## **615 Albany St Proposal**

### **MAY 7th SEDLC Meeting Comments and Notes:**

# Albany Street Residences

DRAWING TITLE:  
**STREET ELEVATIONS**

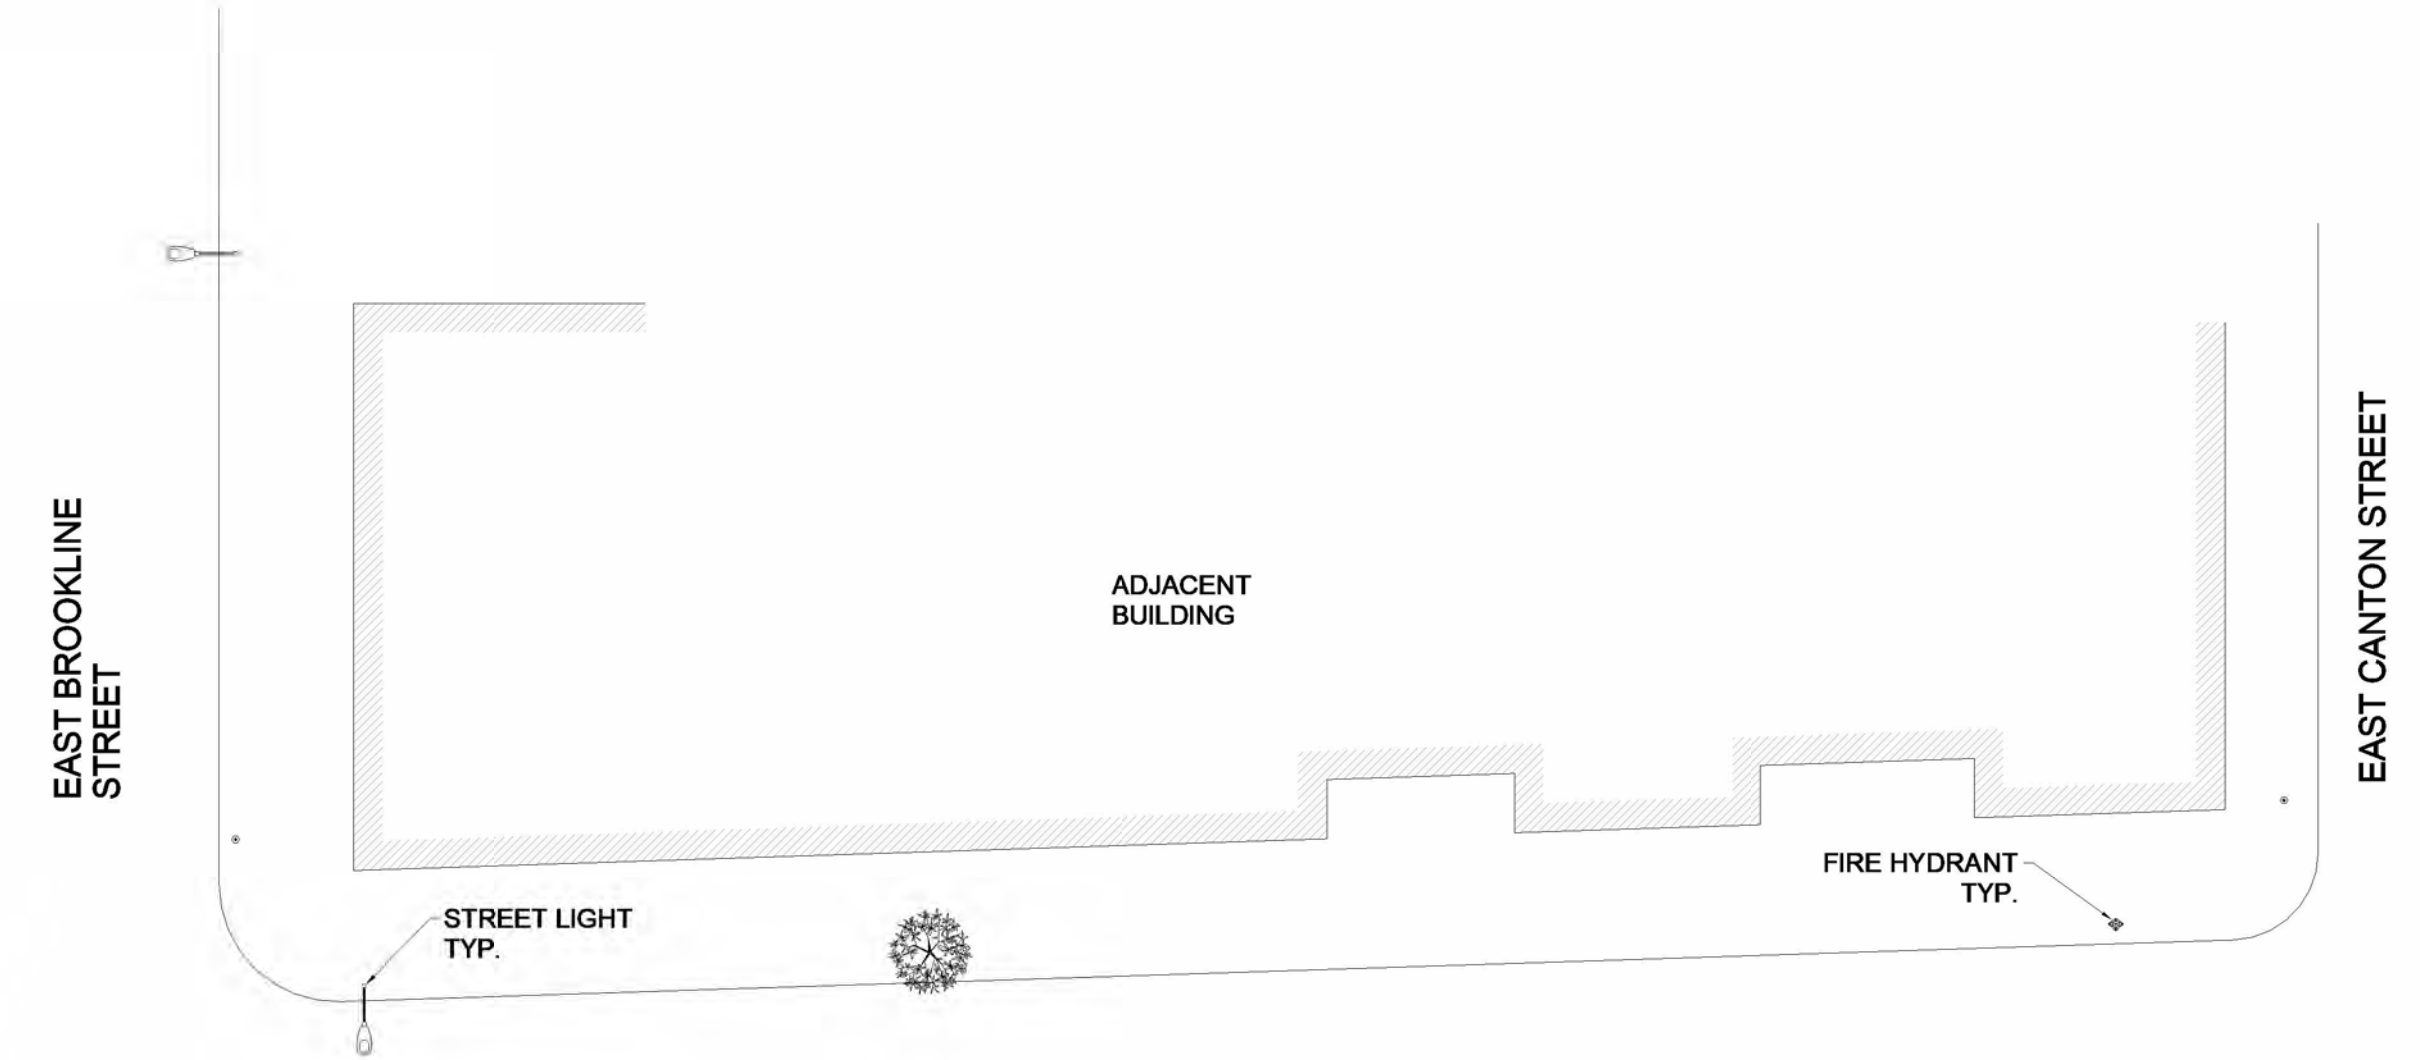
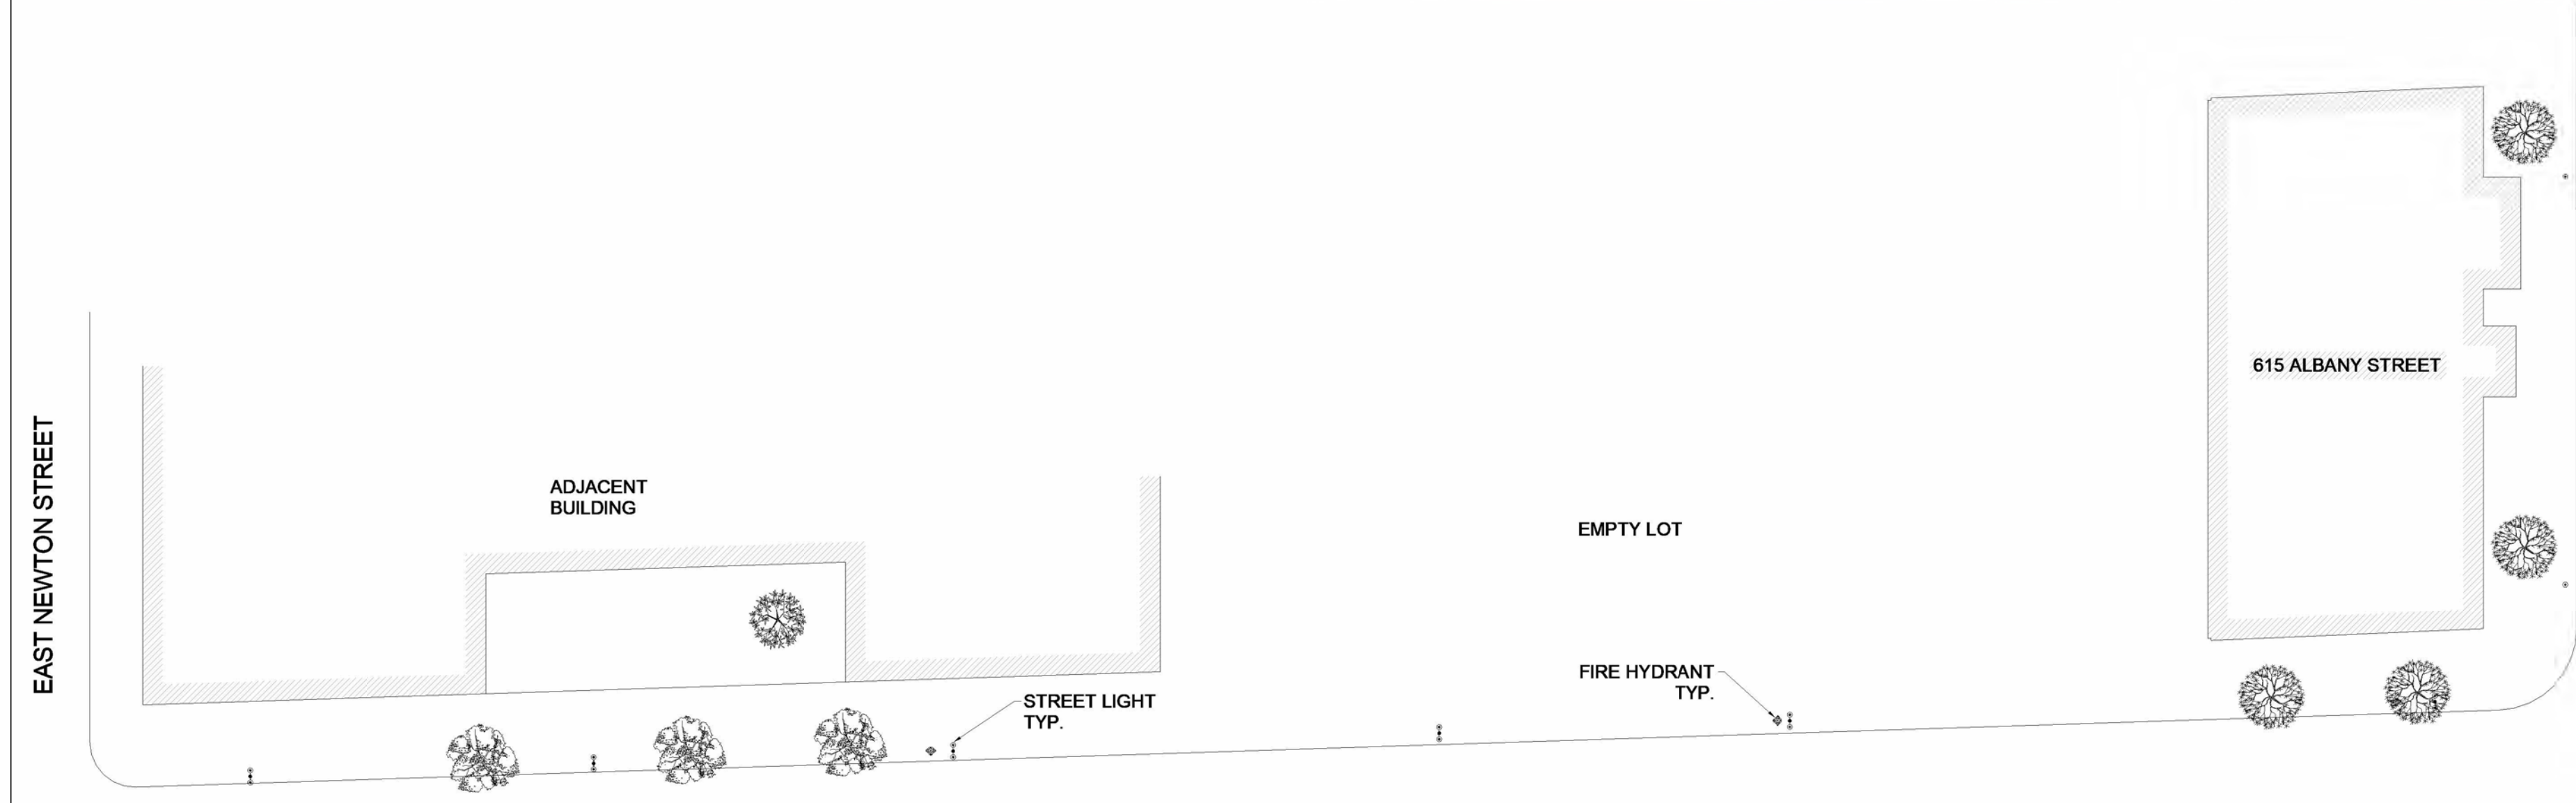
Concerns were raised about the addition and setbacks. The renderings were not available at this time and the movement on the 5th and 6th story was difficult to see from the elevations. It was recommended again the proportions should match the building below better.

Response: We have revisited the setback of the 5<sup>th</sup> and 6<sup>th</sup> floor addition to address the proportions of the building below. A portion of the 5<sup>th</sup> and 6<sup>th</sup> floor is still “pulled out” to align with the brick below the corbels, but they are proportioned and centered to better address the over all scale of the building and neighboring buildings on Albany Street.
